IMPORTANT SAFETY RECALL

NHTSA Recall No. 23V-396

SN719

SUBJECT: Subframe Insert Welds

Figure 1. Area of subframe to inspect

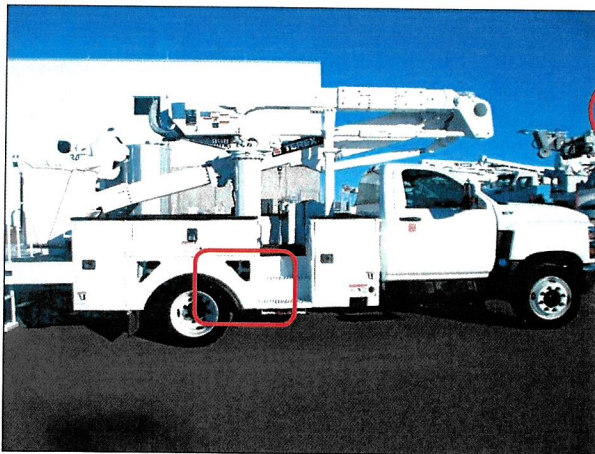
Terex TL48 model aerial devices, produced from February 2021 through September 2021, may have subframe weld issues. The welds for the threaded inserts that the aerial device mount to may crack loose from the surrounding subframe material. **Failure of the subframe welds could cause the boom to separate from the truck frame which could result in injury or death.**

1. Immediately inform all users, operators, and supervisors that the bottom side of the subframe where the aerial device mounts must be visually inspected before further use.
2. Inspect to determine if welds are cracked for the threaded inserts using the figures below as reference.

Terex will complete Field Service Kit Z1650 at no cost to the customer. The Field Service Kit Z1650 provides instructions for removing the welds for the threaded inserts at the top of the subframe and to reweld the top side of the inserts to the subframe tubes.

Figure 2. Weld to inspect

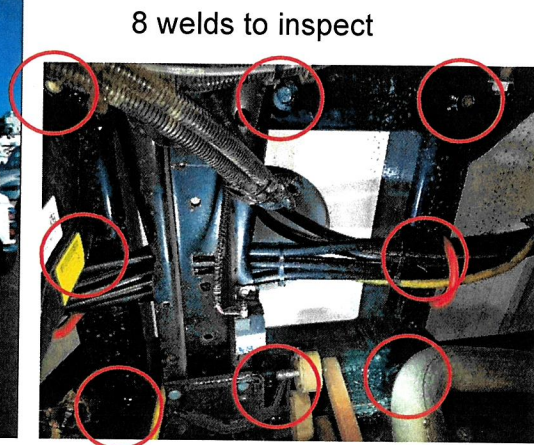
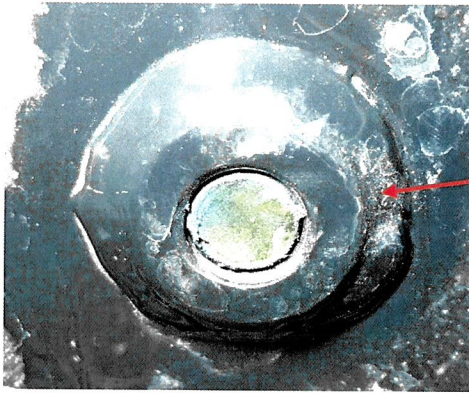
Inspect this weld
for cracks
